World Forum for Harmonization of Vehicle Regulations

Proposal for Supplement 2 to the 03 series of amendments to Regulation No. 107 (M₂ and M₃ vehicles)

Submitted by the Working Party on General Safety Provisions*

"Figure 6:
Gangway Mannequin.

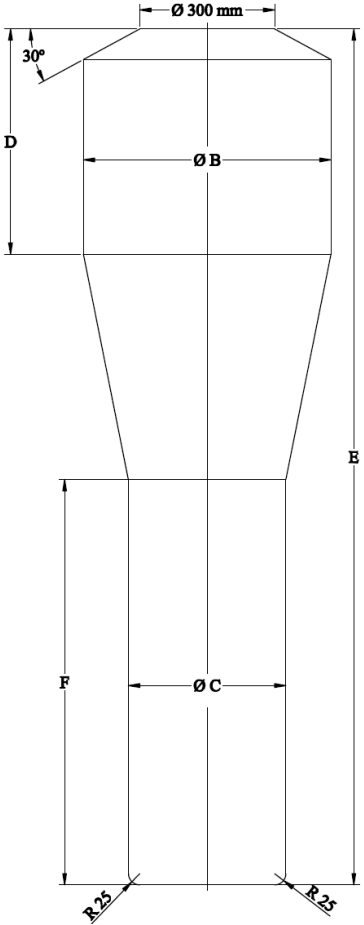
The text reproduced below was adopted by the Working Party on General Safety Provisions (GRSG) at its ninety-ninth session in October 2010 in order to incorporate a 25 mm radius at the base of the gangway gauging device and to prohibit escape hatches fitted in the roof of a vehicle when the use of such hatches may present a danger to passengers. It is based on ECE/TRANS/WP.29/GRSG/2010/27 not amended and ECE/TRANS/WP.29/GRSG/2010/35 not amended. It is submitted to the World Forum for Harmonization of Vehicle Regulations (WP.29) and to the Administrative Committee (AC.1) for consideration (ECE/TRANS/WP.29/GRSG/78 paras. 8 and 16).

Annex 4, Figure 6, amend to read:
